Adrian Hatton – Affected party.

Issues raised at CA Hearing on 3rd December 2024:

Representation: Adrian Hatton - Affected Person AFP166

Annex 2

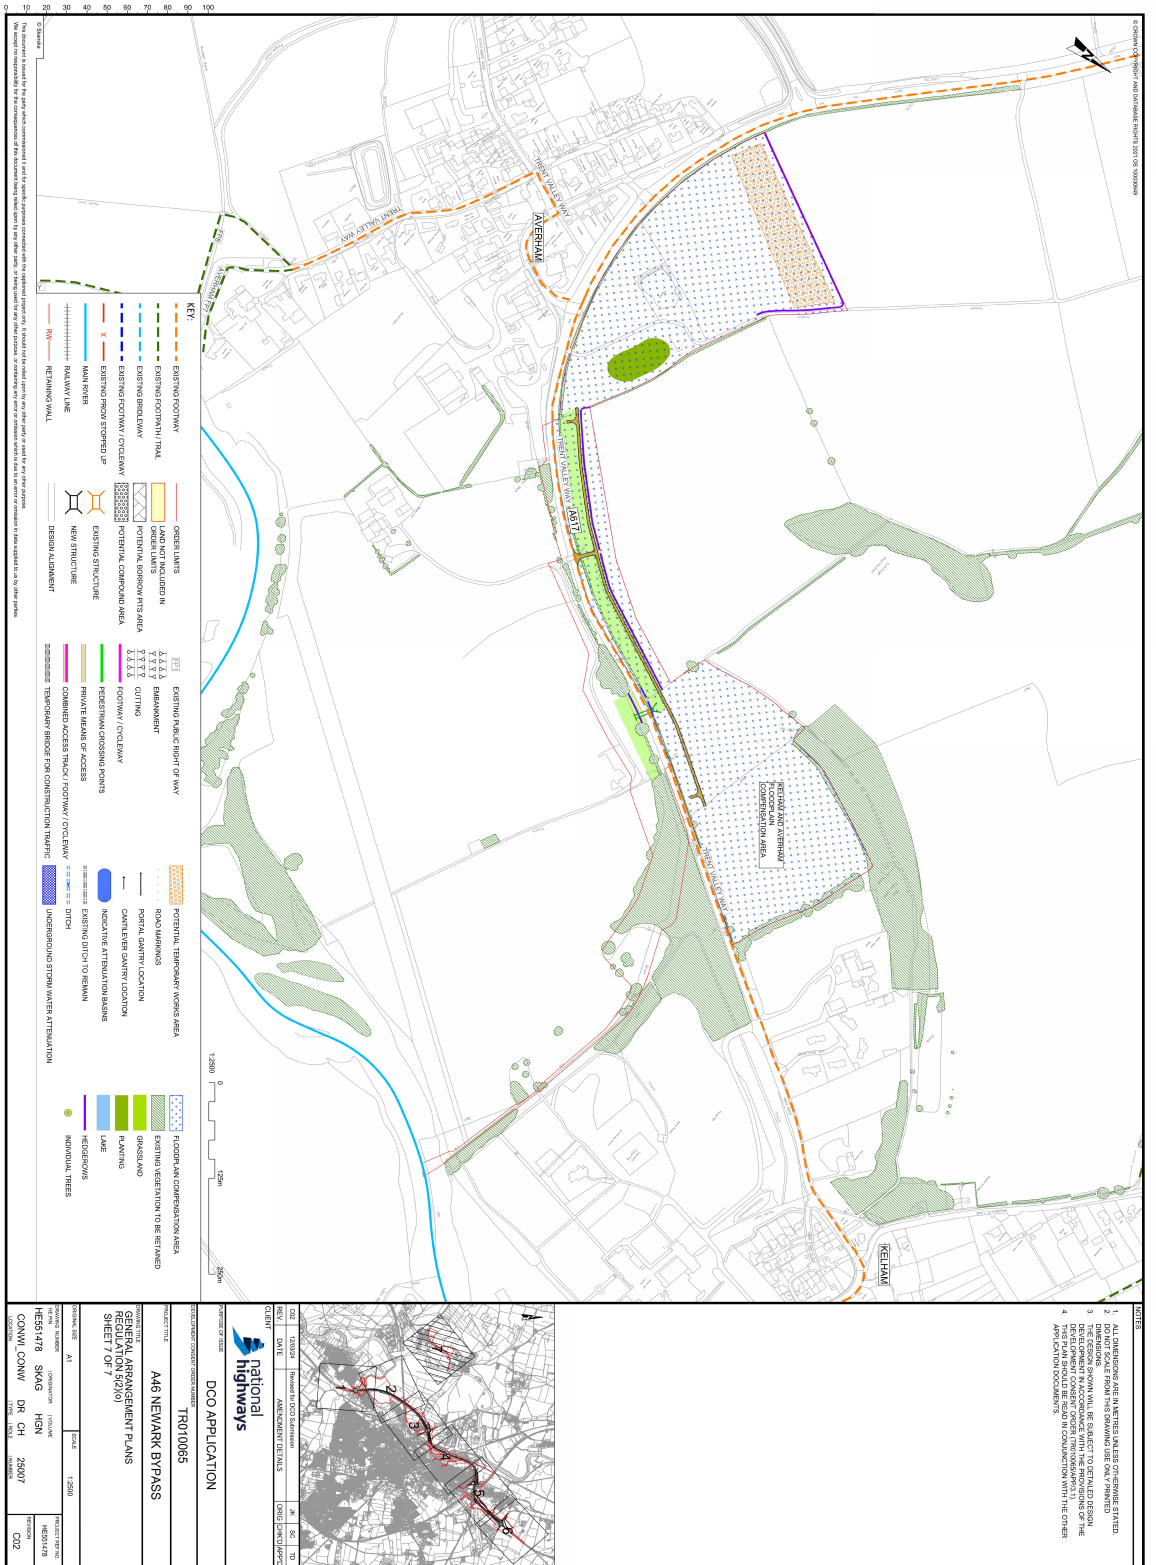
- ii) For the Kelham FCA to work, in addition to culvert work beneath the A617, it requires suitable enhancement of existing drainage system on land East of A617 to ensure free flow of water to and from the FCA with no adverse effect on that land. For example, neither General Arrangement Drawing TR010065, sheet 7 of 7 nor works plan Sheet 7 (REP 3-002) show the presence of the bridge and location of the single (c.250mm?) diameter culvert passing beneath a farm access within Land plot 7/2d – this would have to carry a good proportion of flood water to and from FCA East of A617 – I would welcome details of how it is proposed to upgrade that ditch and culvert to cope with expected volumes of water.

- iii) The DCO plans omit the presence of field access off A617 at SE corner of Red House Field SK7655 8525 (within plot 7/4e) – there is no depiction of the existing gateway and access track on Applicant General Arrangement Drawing TR010065, sheet 7 of 7 (see Annex 2 below), nor is there recognition of preserving existing access points and providing appropriate bridges to afford safe pedestrian and vehicular passage over the Applicant's proposed hydraulic link channel at all times. Other access points depicted are incorrectly located on drawings.

- iv) General Arrangement Drawing, sheet 7 (see Annex 2) and Works Plan sheet 7 do not show the required new access to be constructed to East of A617 to provide access for construction and ongoing maintenance access of the A617 culverts and drainage system on East side of A617 to the Trent.
